Project	IEEE 802.16 Broadband Wireless Access Working Group < http://ieee802.org/16 >	
Title	Periodic Ranging protocol update	
Date Submitted	2006-09-22	
Source(s)	Giulio Cavalli Siemens SS11 Padana Superiore km158 20060 Cassina de Pecchi (Milano) Italy	Voice: +39 0224376380 Fax: +39 0224376726 mailto: giulio.cavalli@siemens.com
Re:	Call for contribution	
Abstract	Periodic ranging alignment	
Purpose	update	
Notice	This document has been prepared to assist IEEE 802.16. It is offered as a basis for discussion and is not binding on the contributing individual(s) or organization(s). The material in this document is subject to change in form and content after further study. The contributor(s) reserve(s) the right to add, amend or withdraw material contained herein.	
Release	The contributor grants a free, irrevocable license to the IEEE to incorporate material contained in this contribution, and any modifications thereof, in the creation of an IEEE Standards publication; to copyright in the IEEE's name any IEEE Standards publication even though it may include portions of this contribution; and at the IEEE's sole discretion to permit others to reproduce in whole or in part the resulting I

Figure 82 – Periodic Ranging receiver process -BS
2

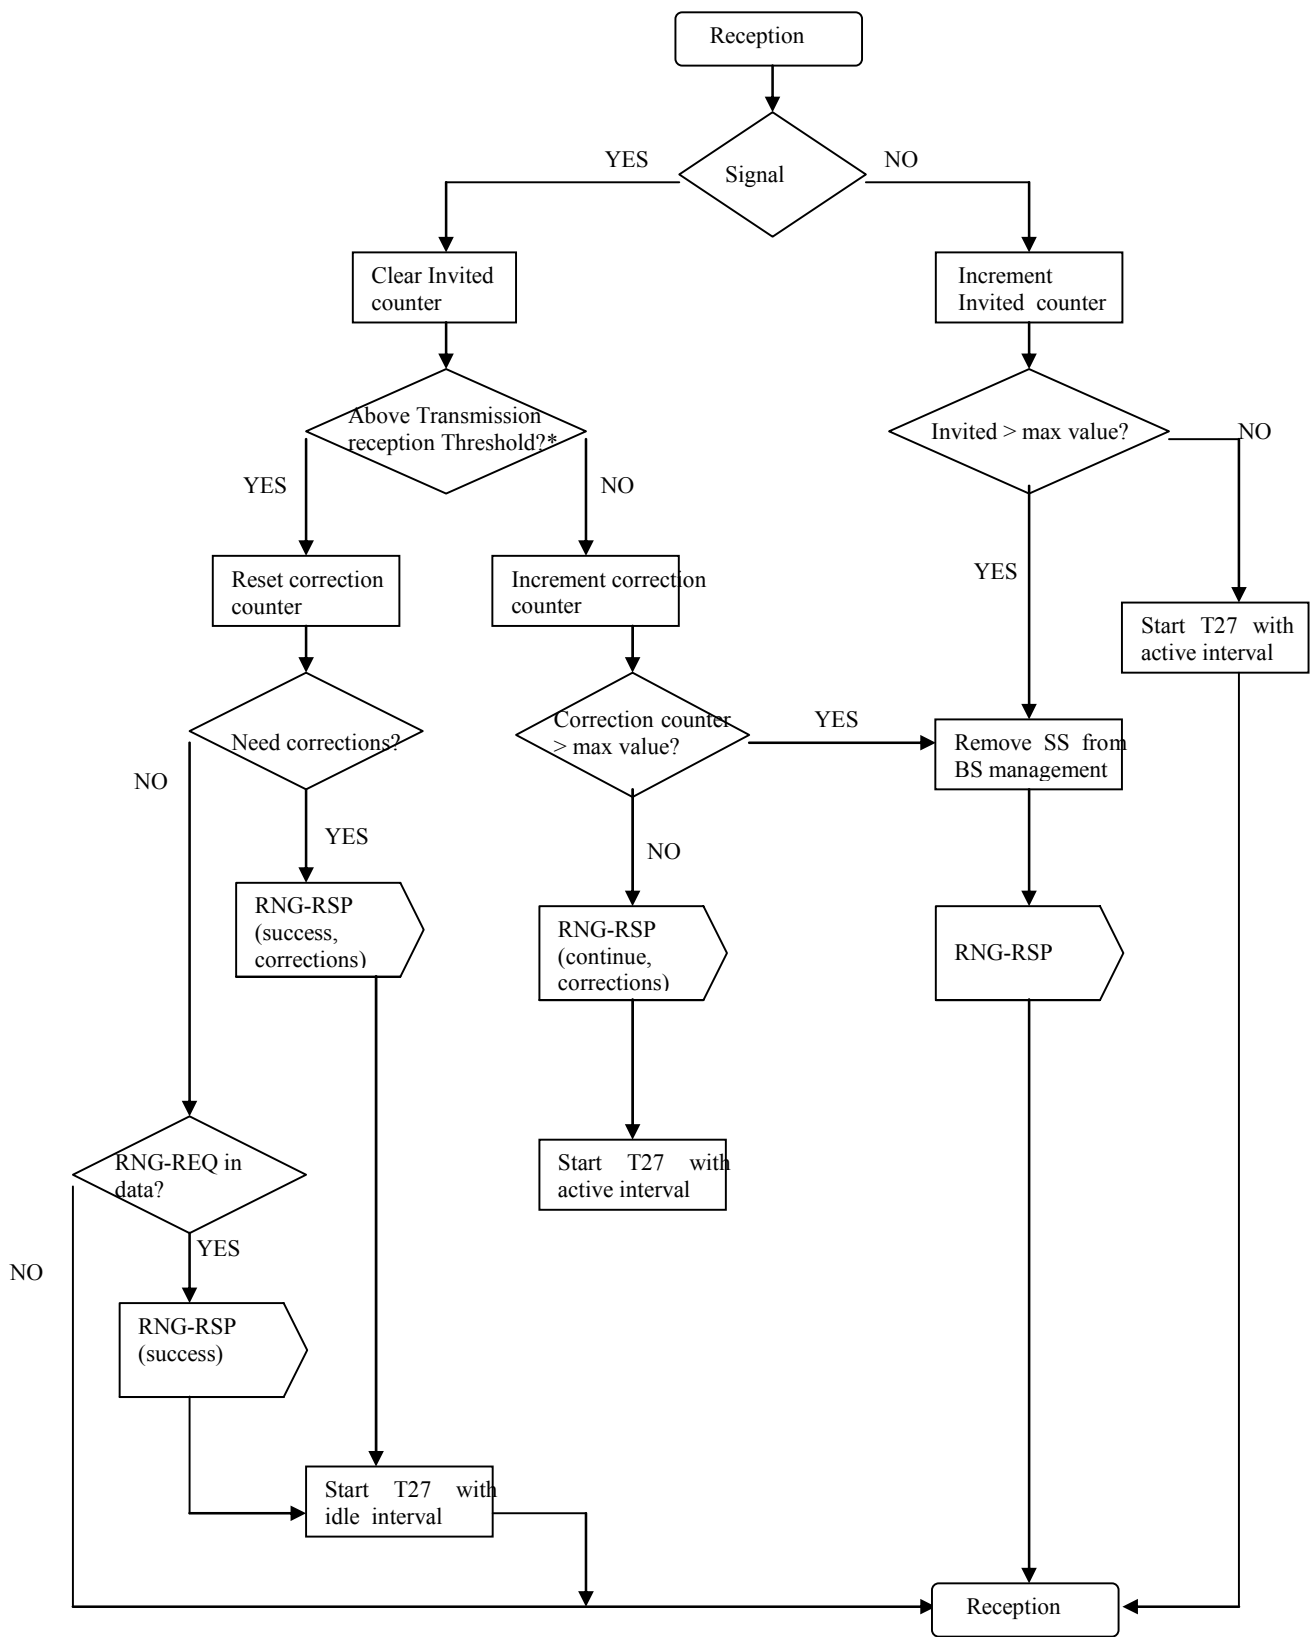
Replace figure 82 with the figure depicted below:

(*) it is implementation dependent
